**BAGHDAD POLICE COLLEGE  
BAGHDAD, IRAQ**

**SIGIR PA-06-078.2**

**JANUARY 29, 2007**

SUBJECT: Report on Project Assessments of Reconstruction Work Performed Under Task Orders 06 and 29 at the Baghdad Police College, Baghdad, Iraq (Report Numbers SIGIR PA-06-078.2 and PA-06-079.2)

Figure 1. Contractor design for installation of hot and cold water lines for cadet barracks showers

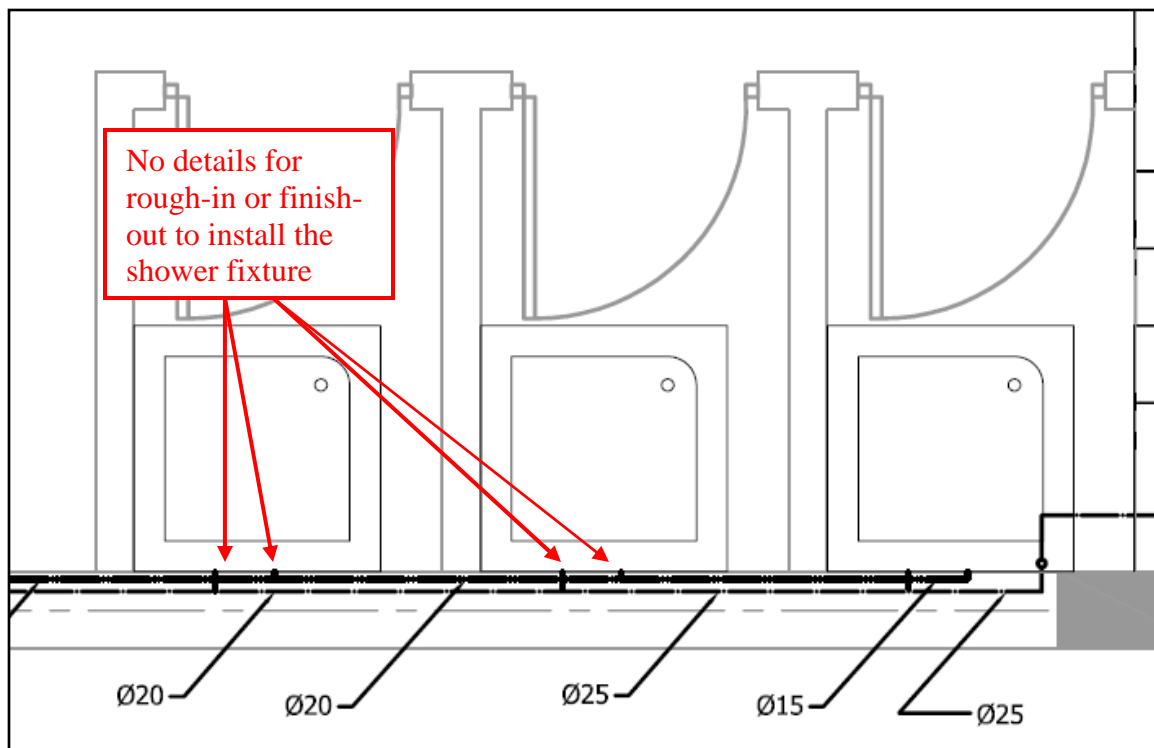
While the government's reviews generally identified poor electrical design drawings by the contractor, there was no mention about the absence of quality, detailed design construction drawings. It is customary to show construction detail for individual items as well as typical details for items or components used at multiple locations. All construction detail shows the material, method, and critical dimensions to perform the task for the benefit of the installer. The contractor's drawings lacked significant and basic design details, such as the rough-in and finish-out for the installation of plumbing fixtures (a riser diagram for both fresh water and soil piping) and the need for an

Detailed design drawings for the rough-in and finish-out of the plumbing fixtures were not provided by the contractor. Instead the drawings were generic and did not specify the distance that the hot and cold water lines should extend beyond the wall (i.e. rough-in) for the plumber to connect to the shower faucet and head (Figure 1). In addition, the drawings do not provide an enlargement of one shower as an example to provide specific installation details, such as the type of plumbing fixtures to use (i.e. finish-out). Without detailed design drawings, the subcontractor does not have adequate guidance to properly install the water lines and plumbing fixtures.

Figure 2. Floor plan and soil pipe detail for a typical cadet barracks facility

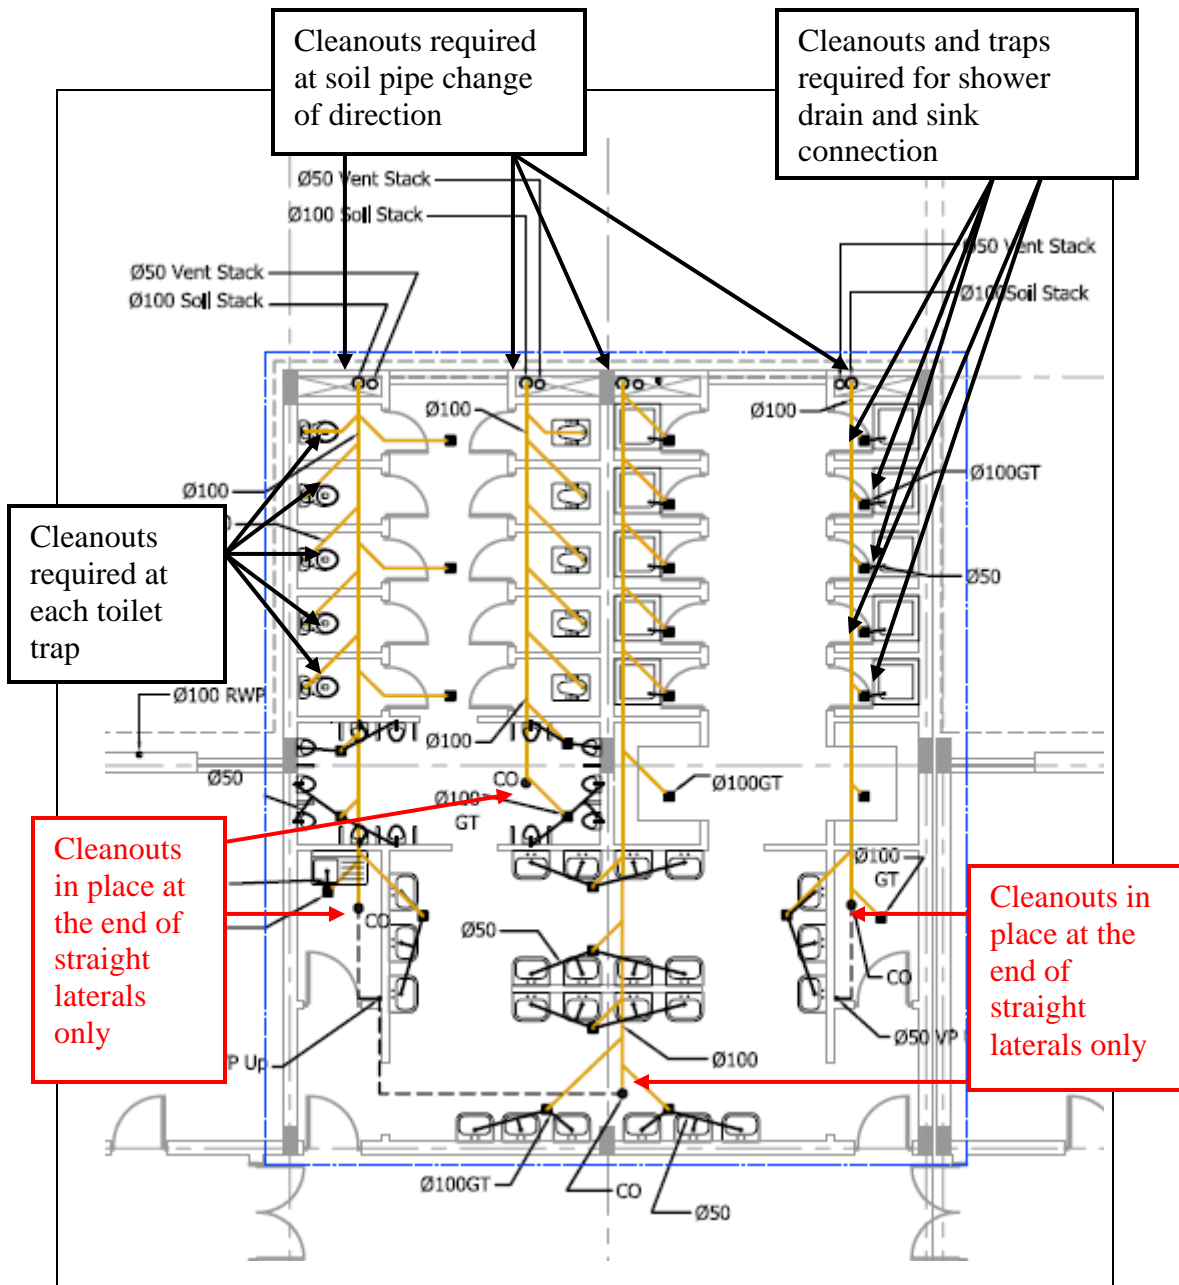
The as-built drawings for the cadet barracks indicate cleanouts were only used at the far end of a straight run of soil pipe, not for every toilet trap and change of direction (Figure 2). The government engineers reviewing the cadet barracks design drawings failed to detect and identify the lack of a sufficient number of cleanouts and traps at the correct locations. As a result, not only did the contractor not follow the specific code requirement, which is compounded by the contractor's poor plumbing installation and construction, but the likelihood of the sewer lines backing up increased significantly, even under normal use.

In addition, on the as-built drawings for the "typical floor drainage" cadet barracks design, the listed design references were the Practical Plumbing Design Guide, National Plumbing Code, and Plumbing Engineering Services Design Guide – The Institute of Plumbing; however; there is no reference to the standards required by the TO – the IPC. Compliance with IPC criteria for design, construction, and installation was required by the TO.

**Figure 4. Contractor's as-built drawing for floor expansion joint**

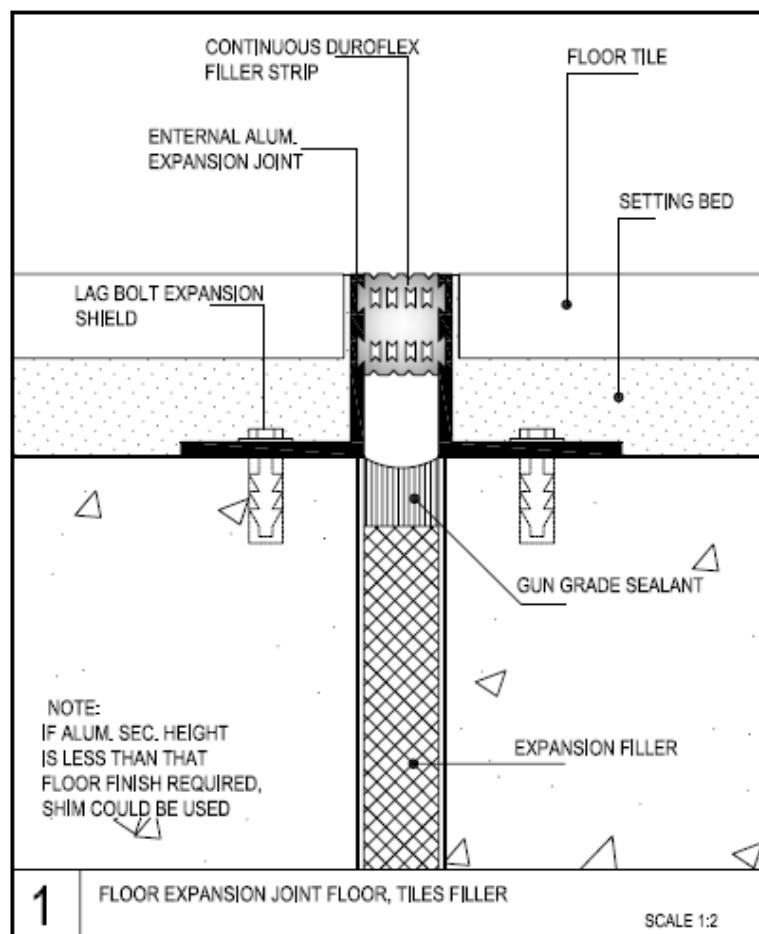
More importantly, we discovered significant expansion cracks on the exterior and interior of the buildings (Site Photos 17-20). We determined that the contractor's as-built drawings (Figure 4) do not reflect the reality of what was actually constructed at the instructors' barracks.

**Figure 5. Contractor's as-built drawing**

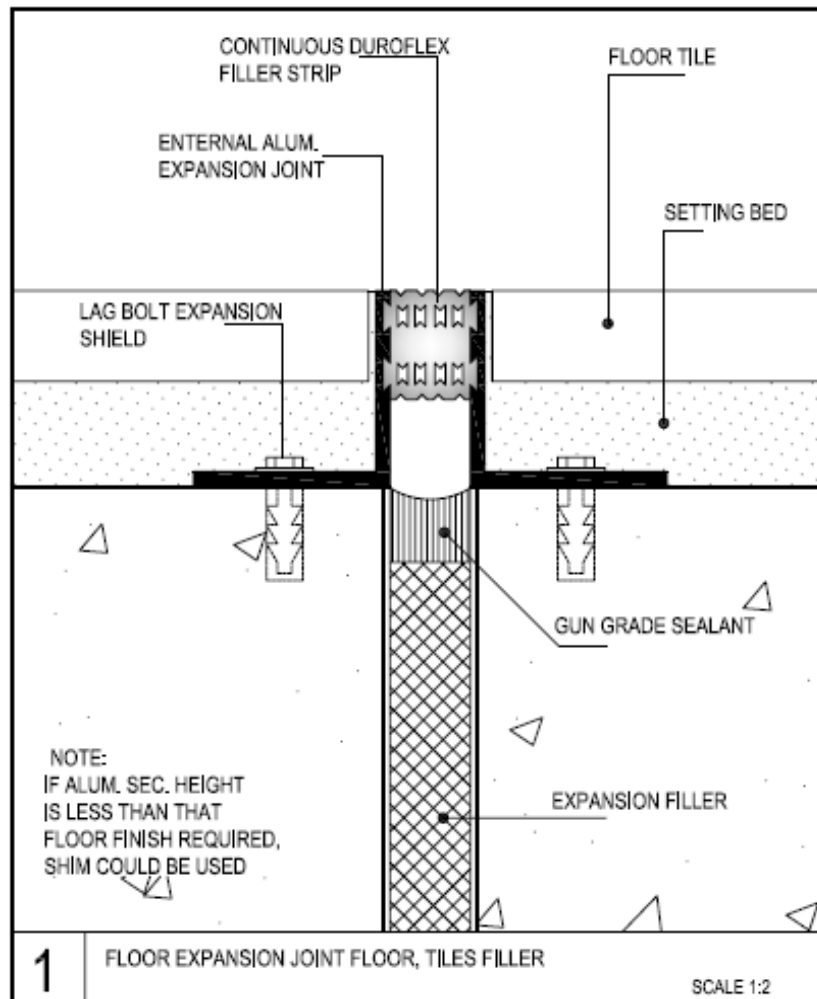
For instance, for the instructors’ barracks, we identified significant expansion cracks on the interior, exterior, and roof of the buildings (Site Photos 65-68). Parsons’ as-built drawings claim to have constructed a specific type of expansion joint system for floor, interior wall, ceiling, exterior wall, and roof (Figures 5 and 6). The as-built drawings submitted show a very specific prefabricated engineered joint system. We found little or no evidence of designed joint systems in place to protect the building from vertical and horizontal movement. When comparing the building’s construction and damage to the as-built drawings submitted by Parsons, it is apparent that the as-built drawings do not reflect the actual construction done.

**Figure 8. Contractor's as-built drawing for ablation unit, which indicates connection to main water and sewage networks.**

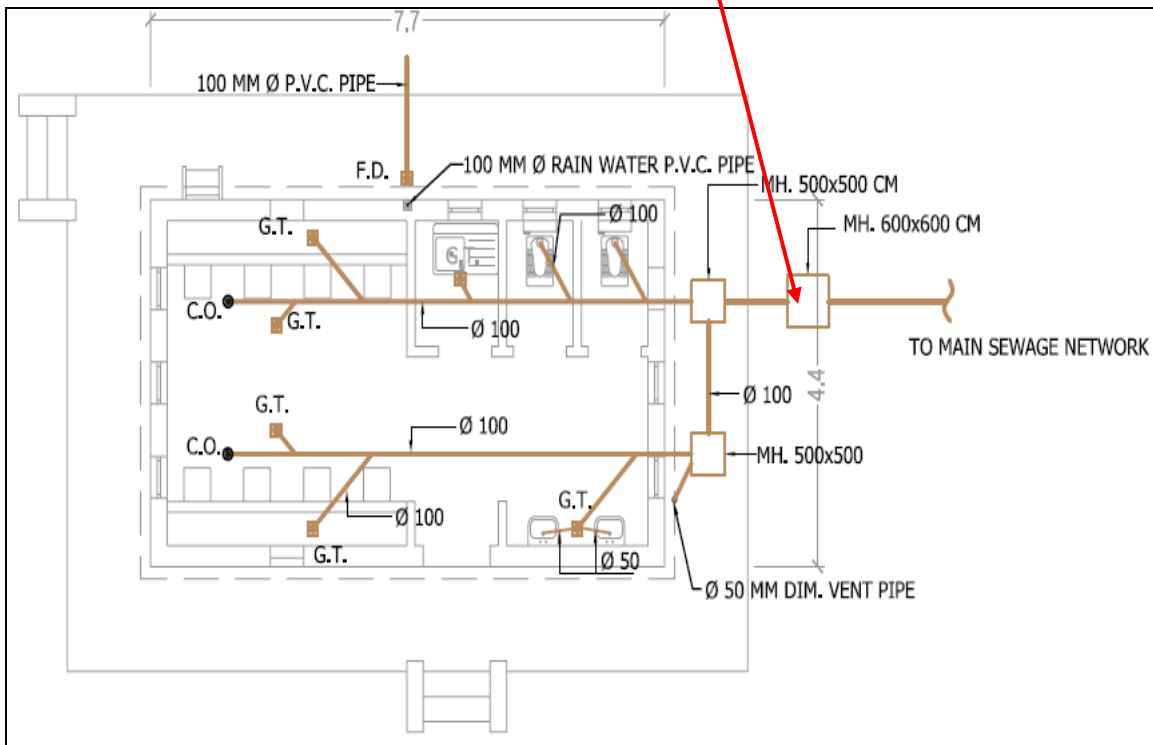
Finally, for the ablution unit, the as-built drawings submitted by the contractor indicate the facility is connected to the main water and sewage networks (Figure 8); however, during our initial site visit, we verified the facility was not connected to either the main water or sewage networks (Site Photo 71). The connection to the main water and sewage networks was not completed until late November 2006 and was completed by another contractor.

**Figure 9. Contractor's as-built drawing**

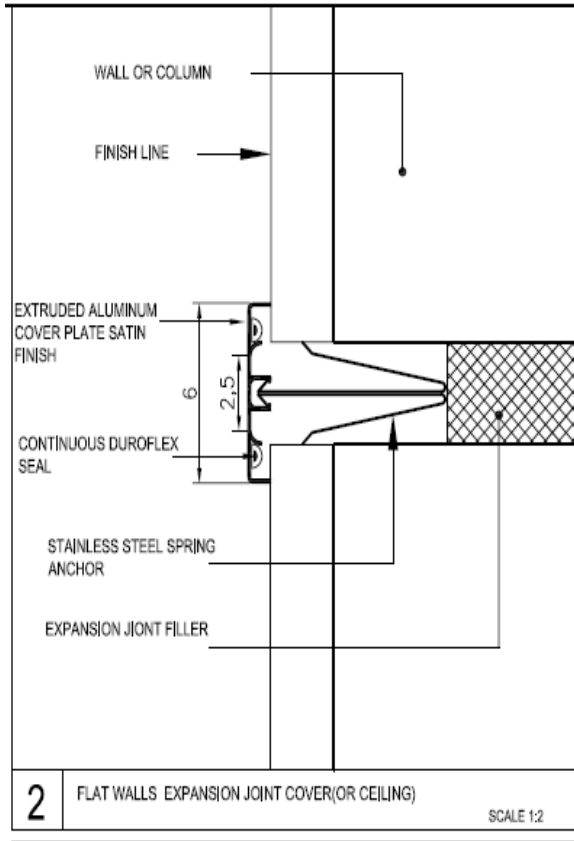
The contractor's as-built drawings, in our opinion and in GRD's own assessment, are not complete and accurate. For example, the as-built drawings for the instructors' barracks buildings show a very specific prefabricated joint system (Figure 9). We found little or no evidence of designed joints in place to protect the building from vertical and horizontal movement. Not only did the instructors' barracks suffer from significant interior and exterior expansion cracks (Site Photos 82 and 83) and runs the risk of reducing the buildings' life expectancy, equally troubling is the fact the GRD does not know if the contractor was paid for installing the prefabricated joint system claimed in the as-built drawings. The government already paid Parsons for inaccurate as-built drawings (since the as-built drawings reference prefabricated expansion joints which are not present on the buildings) and quite possibly paid Parsons for the installation of the prefabricated joint system.

Figure 10. Contractor design for installation of hot and cold water lines for cadet barracks showers

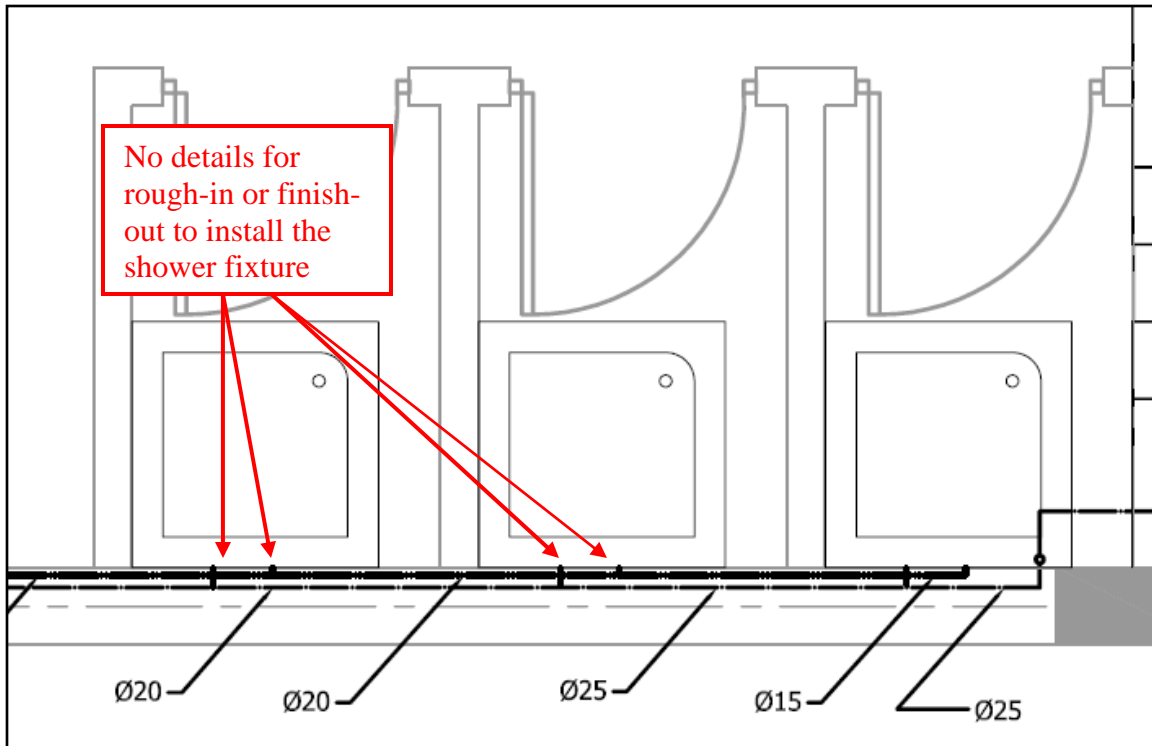
Detailed design drawings for the rough-in and finish-out of the plumbing fixtures were not provided by the contractor. Instead the drawings were generic and did not specify the distance that the hot and cold water lines should extend beyond the wall (i.e. rough-in) for the plumber to connect to the shower faucet and head (Figure 10). In addition, the drawings do not provide an enlargement of one shower as an example to provide specific installation details, such as the type of plumbing fixtures to use (i.e. finish-out). Without detailed design drawings, the subcontractor does not have adequate guidance to properly install the water lines and plumbing fixtures.

**Figure 11. As-built drawing for expansion joint**

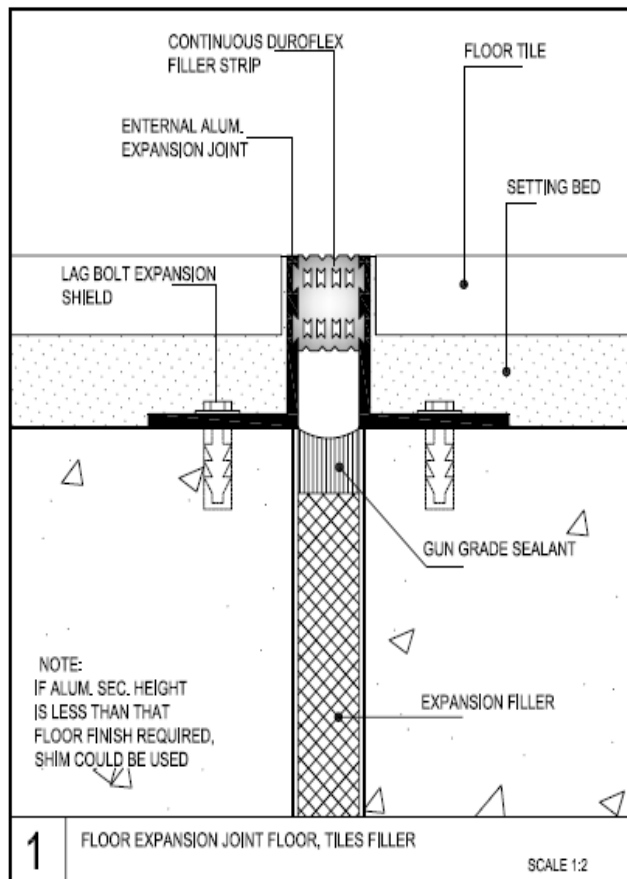
We found little or no evidence of designed joints in place to protect the building from vertical and horizontal movement. Properly designed and correctly installed joint systems are capable of protecting buildings and structures from damage caused by thermal expansion and contraction as well as anticipated foundation movements. The damage we identified is a direct result of not properly installing the expansion joints according to the as-built drawings (Figures 11 and 12 and Site Photos 132-135). The absence of properly installed expansion joints could potentially result in further damage to the buildings' interior and exterior, as well as, significantly reduce the buildings' life expectancy.

**Figure 13. As-built drawing for expansion joint**

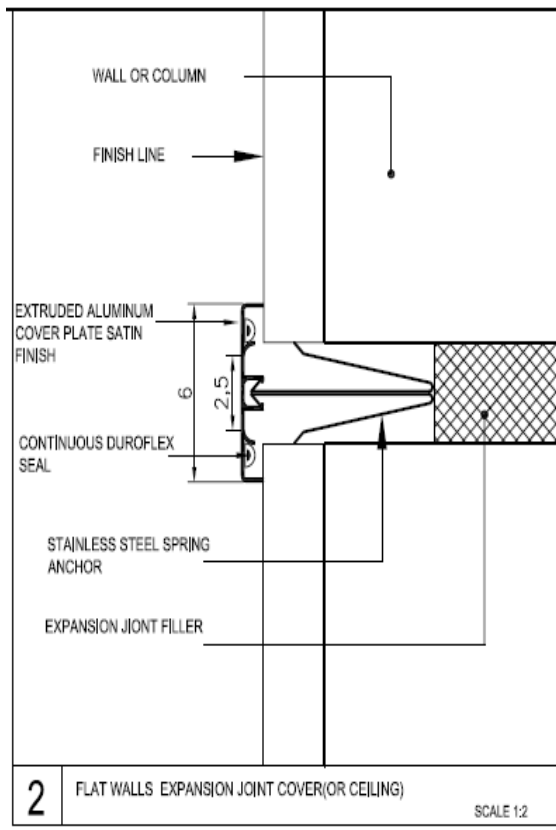
We found little or no evidence of designed joints in place to protect the building from vertical and horizontal movement. Properly designed and correctly installed joint systems are capable of protecting buildings and structures from damage caused by thermal expansion and contraction as well as anticipated foundation movements. The damage we identified is a direct result of not installing the expansion joints according to the design drawings (Figure 13 and Site Photos 138 and 139). The lack of properly installed expansion joints could potentially result in further damage to the buildings' interior and exterior, as well as, significantly reduce the buildings' life expectancy.

Figure 14. As-built drawing for the dining hall with no attached kitchen

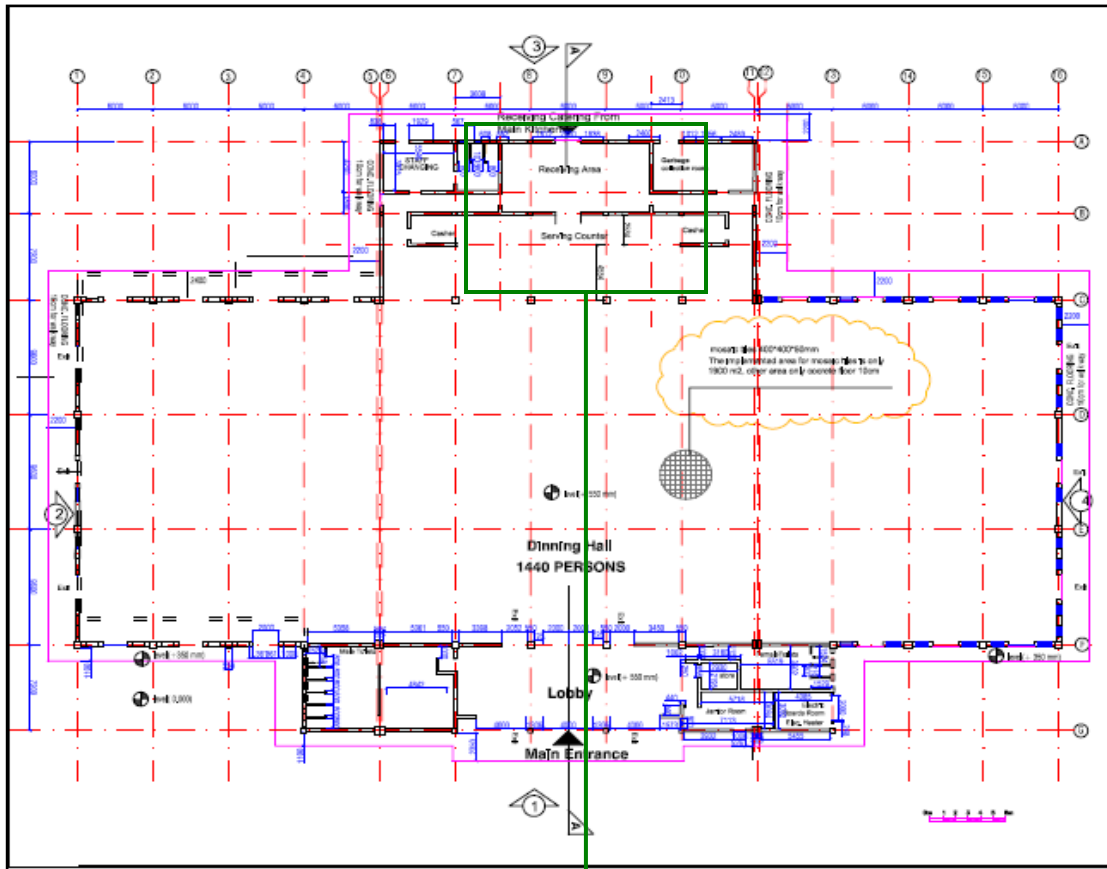
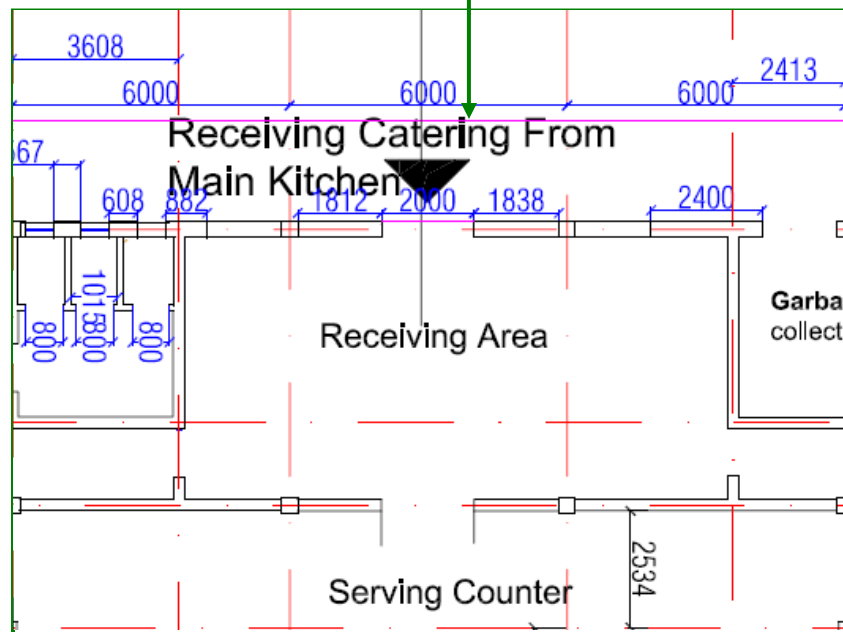
include the “attached” kitchen required by the TO. The government representative who reviewed Parsons’ design submittals did not mention the complete omission of the attached kitchen. GRD representatives, including the QAR did not realize the omission, either. GRD representatives believed the small room attached to the dining facility was the kitchen; however, this room is actually the receiving and servicing area for the dining facility (Site Photo 194 and Figures 14 and 15). No comment or clarification regarding this issue was raised at the time of design review. When the dining facility is completed, food will have to be brought in from the existing kitchen located on the BPC grounds. GRD representatives are now attempting to locate funding to construct a kitchen for the dining facility.
